**SUBJECT:** Safety Recall 05S28 - Supplement #9  
 Certain 1994-1996 Model Year Bronco, 1994-2002 F-150 through F-550, 1997-2002 Expedition, 1998-2002 Navigator, 2002 Blackwood, 1994-1996 E-150/250/350, 1996-2002 E-450, 2000-2002 Excursion, and 1998 Explorer and Mountaineer vehicles equipped with Speed Control – Speed Control System Modification

**New! REASON FOR SUPPLEMENT #9**

- *Announce new, more robust, electrical grease called "**Electrical Grease II**". This new electrical grease is to be used when performing Labor Operation 05S28E.*
- *Update the technical instructions to direct technicians to use the Electrical Grease II.*
- *Update the claiming instructions in Attachment I to reflect the cost of the new electrical grease.*
- *Highlight unique Speed Control Deactivation Switch location and accessibility on E-450 applications.*

FIGURE 5

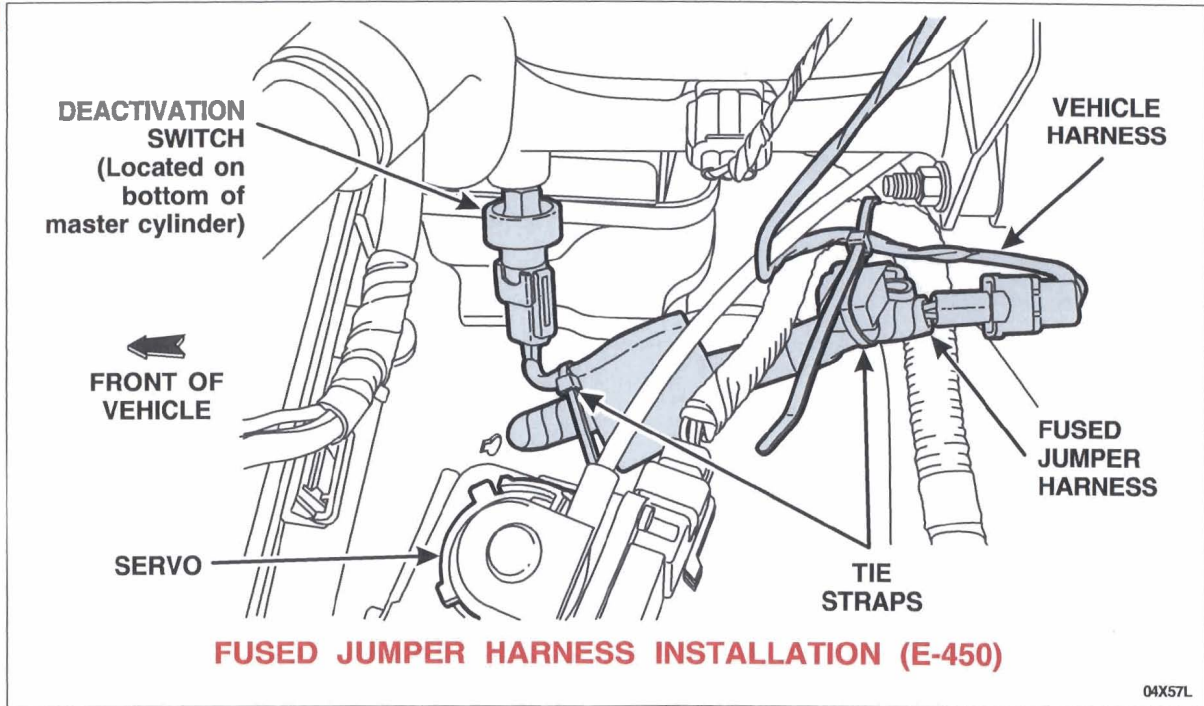
1. Connect the fused jumper harness (14A411) to the speed control deactivation switch and the vehicle harness.
2. On E-450 models, secure the 2-wire take out to the larger portion of the fused jumper harness before installation, as shown in Figure 5.

4. Secure the jumper to the existing harness with tie straps, making sure the fuse holder is positioned vertically with the cap facing upward. Wrap the tie straps underneath, then over the top of the existing harness and verify proper fuse holder orientation. See Figures 4 and 5.

FIGURE 7

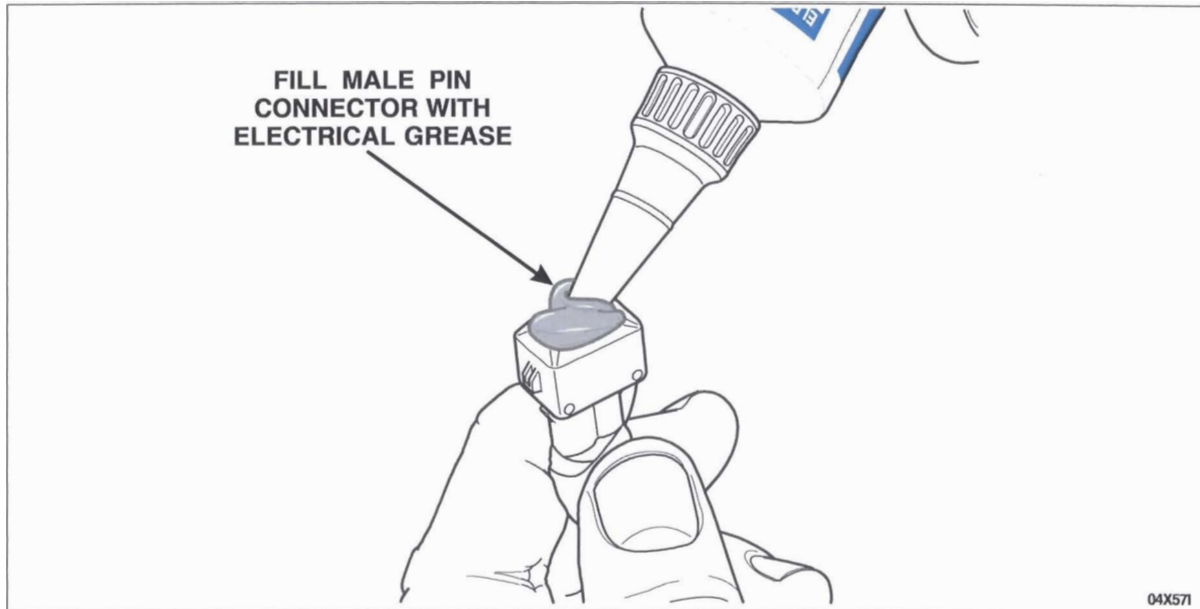
3. Install the *new* speed control deactivation switch into the master cylinder and tighten to 18 Nm (13 lb-ft).
4. **With the speed control servo disconnected, use shop air *only* to blow the speed control deactivation switch harness electrical connector and the servo connector dry of any trace of brake fluid. DO NOT USE ANY TYPE OF SOLVENT TO CLEAN THE CONNECTORS.**
5. Cut approximately 3 mm (1/8 in) off the grease tube applicator tip.
6. **Before installing the jumper harness, fill the vehicle harness end of the jumper (male pin connector end) with Motorcraft Electrical Grease II XG-15-A. See Figure 7.**

**New, more robust, electrical grease (Electrical Grease II, Part # XG-15-A) is available. It is to be used when performing Labor Operation 05S28E. The instruction for Labor Operation 05S28E is revised with the part number for the new electrical grease. For all future 05S28 repairs, dealer technicians are directed to use Electrical Grease II XG-15-A where the original XG-12 was called for previously.**

FIGURE 8

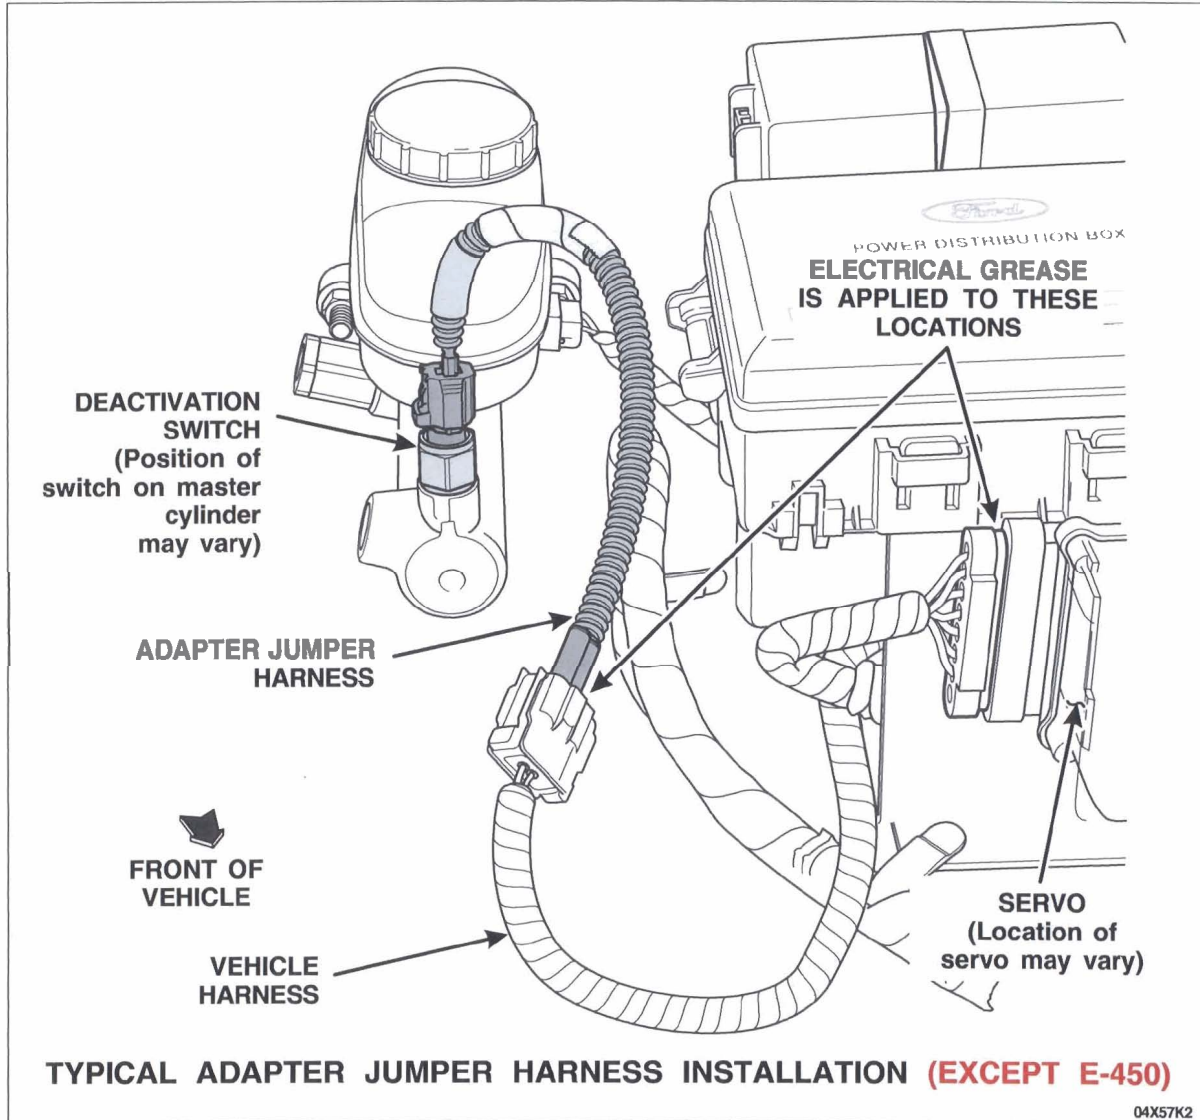
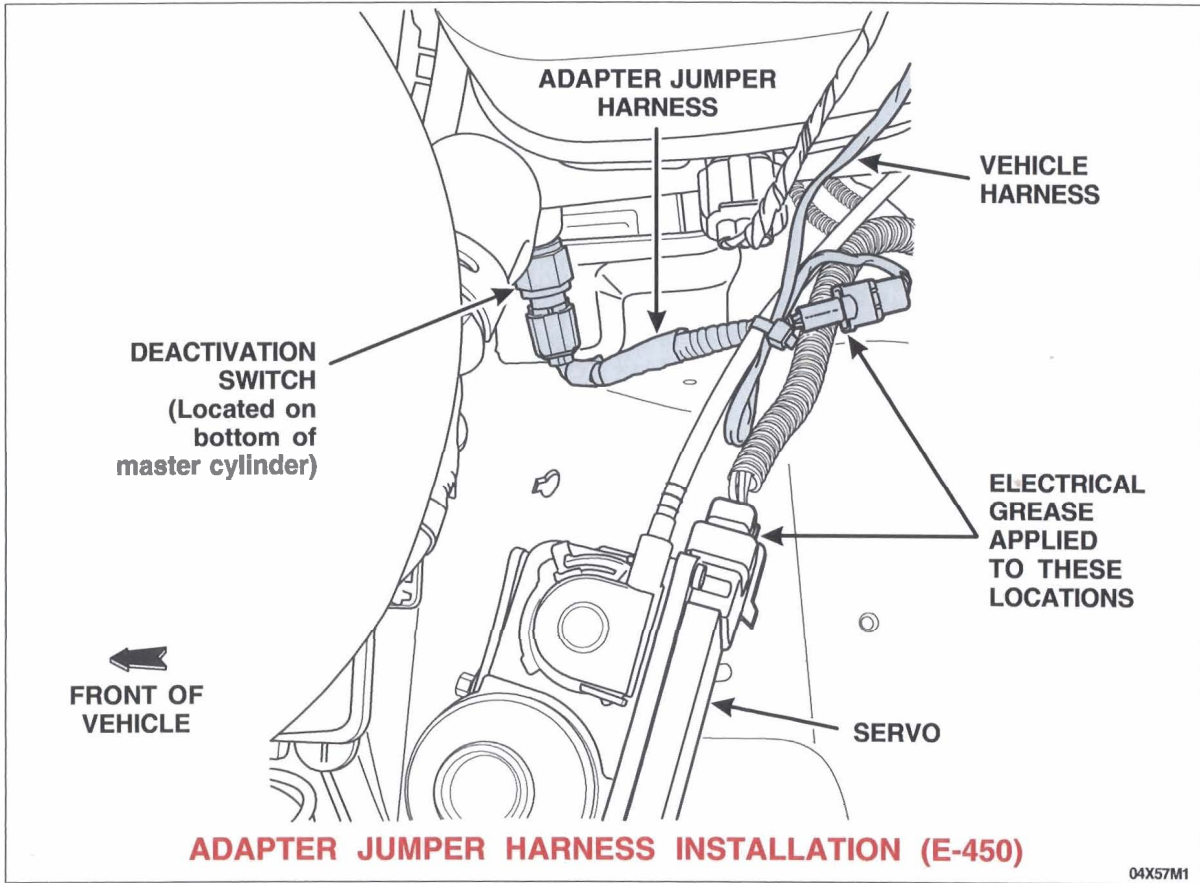
7. Install the adapter jumper harness by connecting it to both the deactivation switch and the vehicle harness. Using the provided tie strap, secure the jumper harness to a nearby component such as the speed control cable or another wire harness. See Figures 8 and 9.

FIGURE 10

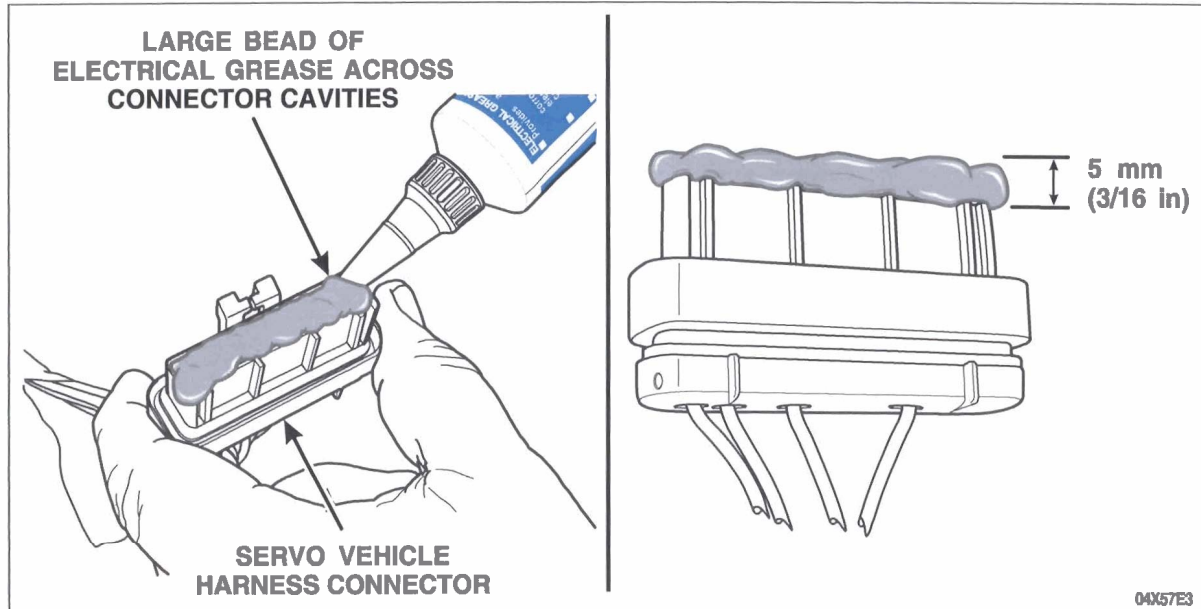
8. **CAUTION:** Be sure to apply an adequate amount of grease to the vehicle harness connector only. **DO NOT** apply the grease directly to the connector of the servo module.

Apply a 5 mm (3/16 in) high bead of Motorcraft Electrical Grease II XG-15-A across the entire width and length of the servo vehicle harness connector. See Figure 10.
